Recycling & Recovery

RE: SSD 15_7267 SUEZ Wetherill Park Transfer Station – development application amendment

3 Amendment 2 - Removal of the proposed small vehicle drop-off area

01 SITE PLAN

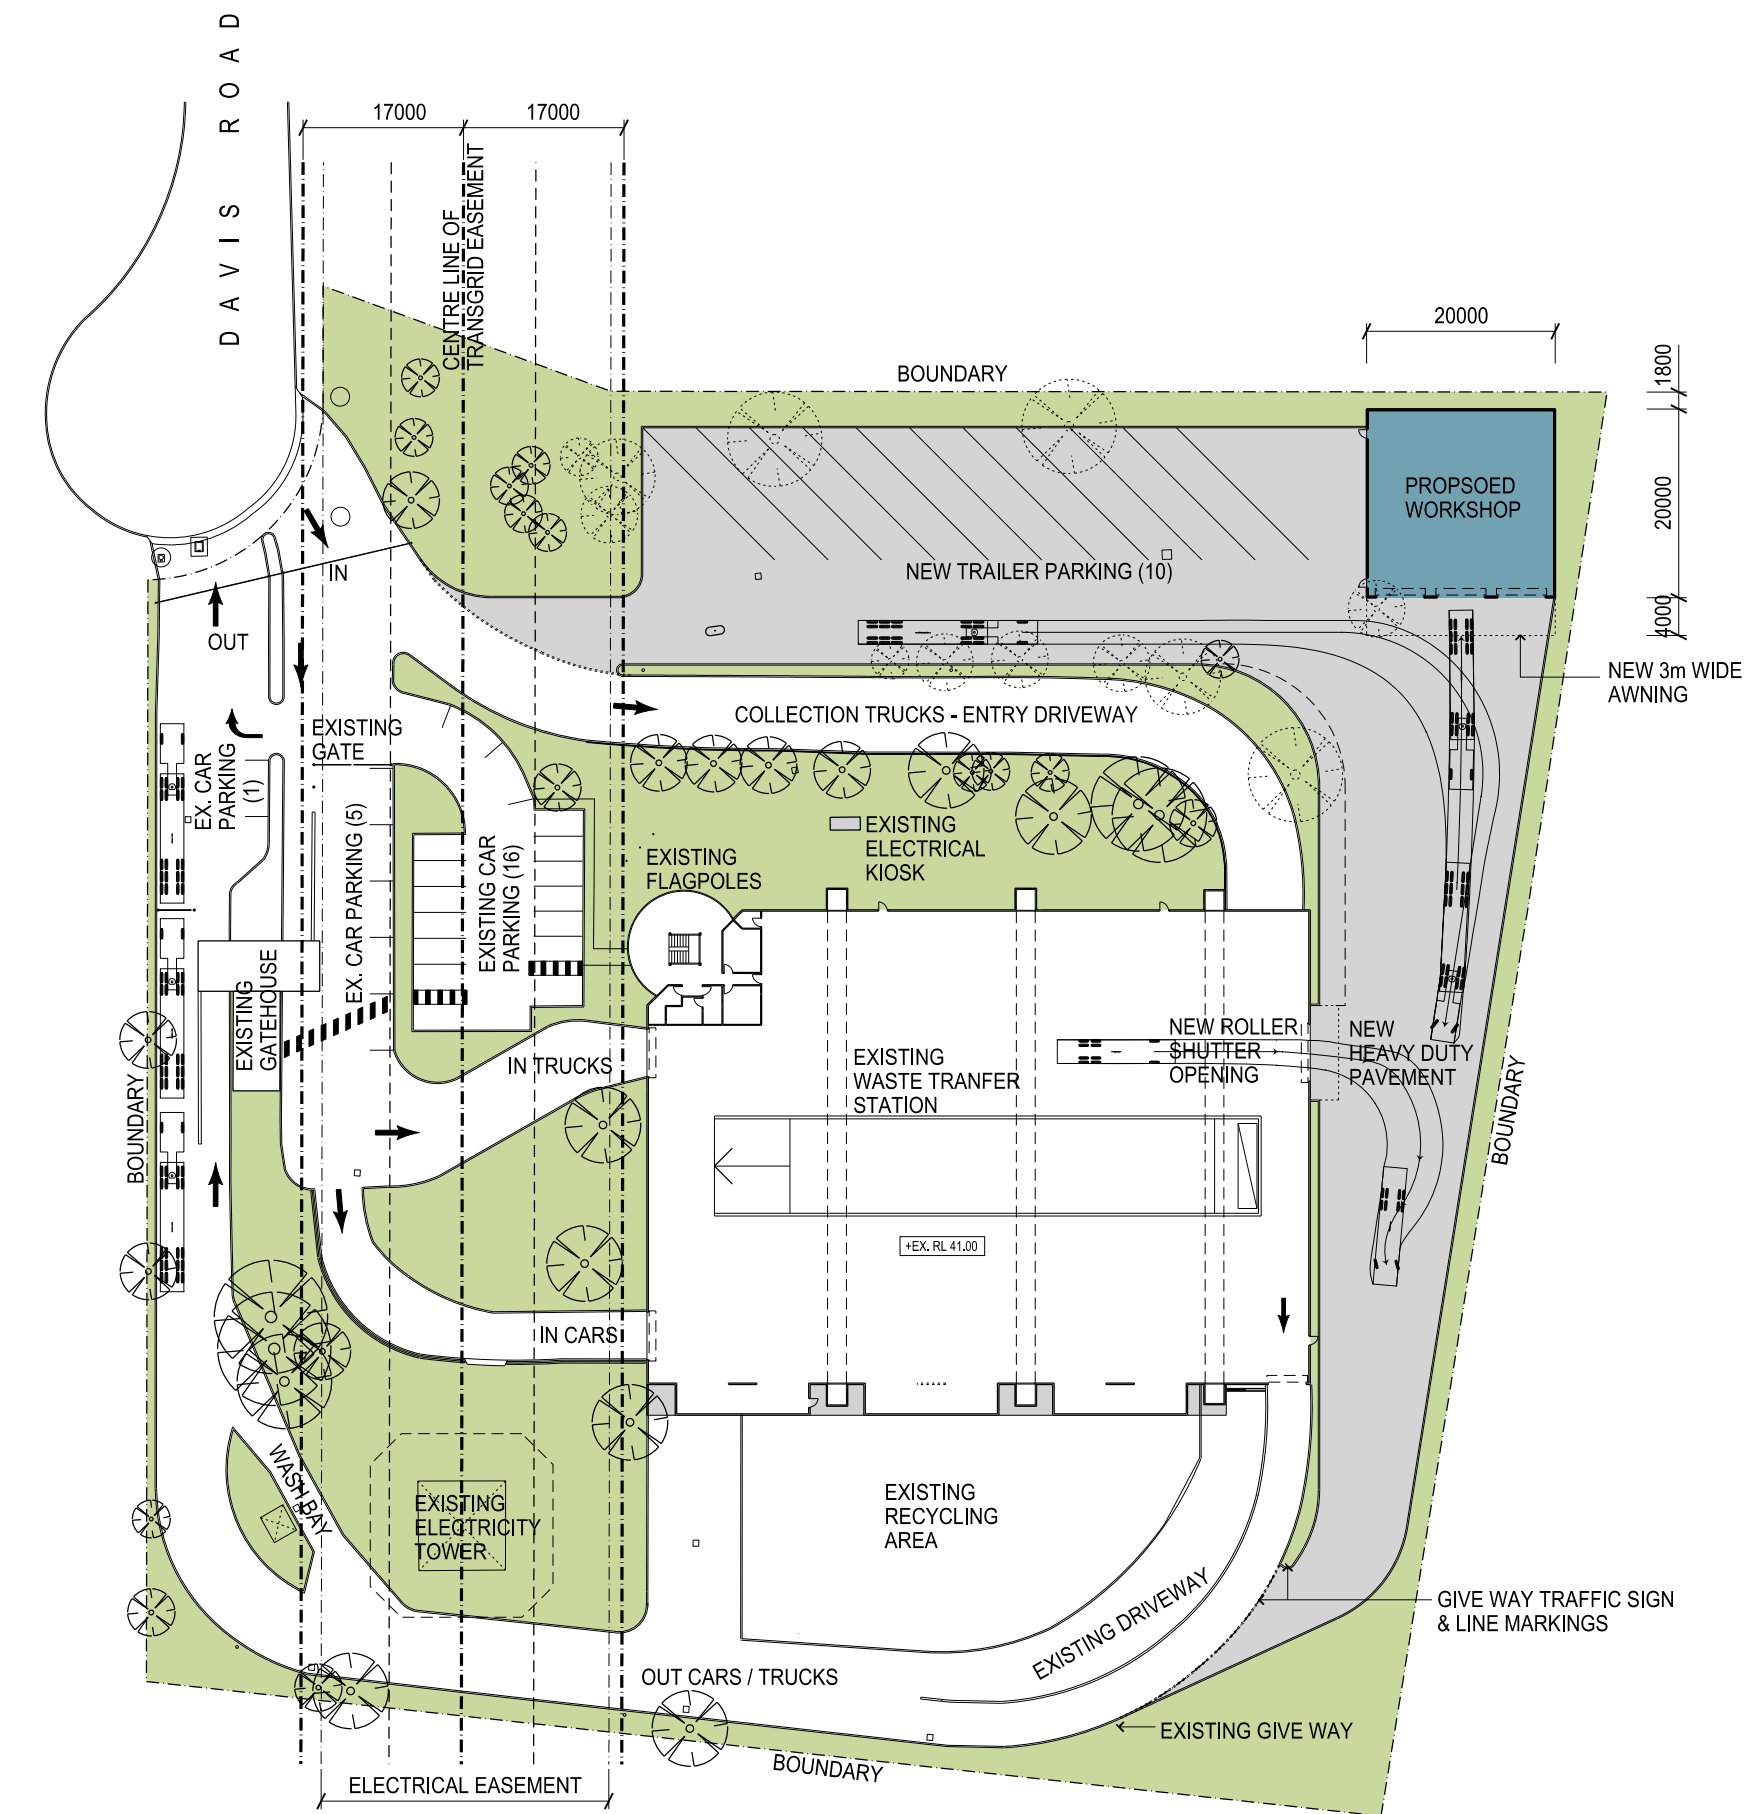
As per my previous email to Susan, the design of the driveway to the car dropoff area within TransGrid's easement must comply with TransGrid's requirements outlined in TransGrid's *Easement Guidelines for Third Party Development*. The proposed driveway located 5 metres from TransGrid's structure is not permissible. A driveway will not be approved when located within 20 metres of any part of a transmission line structure.

- There are two components of the proposed works that are currently within the Transgrid easement – the driveway to the proposed trailer parking and the driveway to the proposed small vehicle drop-off area (refer site plan DA101).
- SUEZ understands that as it currently stands the driveway to the small vehicle dropoff area will not be approved by Transgrid as it is within 20m of the transmission line structure.
- We understand all works within the Transgrid easement require Transgrid's assessment and approval, including provision of a 3D DXF file for Transgrid's assessment.

Based on the Concept Design Plans in Appendix F of the EIS it appears that part of the driveway (shown in grey) to the new waste drop off area may be proposed, not existing. Please confirm whether this part of the driveway is proposed? Are you aware of any works proposed within TransGrid's easement/Restrictive Covenant area, e.g. new hardstand area?

SUEZ's design originally included a small vehicle drop-off area dedicated to manage small vehicles. Upon consideration of TransGrid's comments received 9 June 2017 and subsequent comments received 22 June 2017, SUEZ agreed to modify the plans to remove the proposed small vehicle dropoff area. Copies of the feedback from TransGrid is provided in Attachment A and the updated plans are provided in Attachment B.

ISSUE															REV.			DESCRIPTION			DATE			DA 101		
P			01			GENERAL AMENDMENTS			22.06.17																	
C			01			ISSUE FOR DEVELOPMENT APPLICATION			08.05.17																	
D			01			ISSUE FOR DEVELOPMENT APPLICATION			01.03.16																	
B			01			ISSUE FOR INFORMATION			23.12.15																	
A			01			ISSUE FOR INFORMATION			21.12.15																	
			01			ISSUE FOR INFORMATION			17.12.15																	
			01			ISSUE FOR INFORMATION			15.12.15
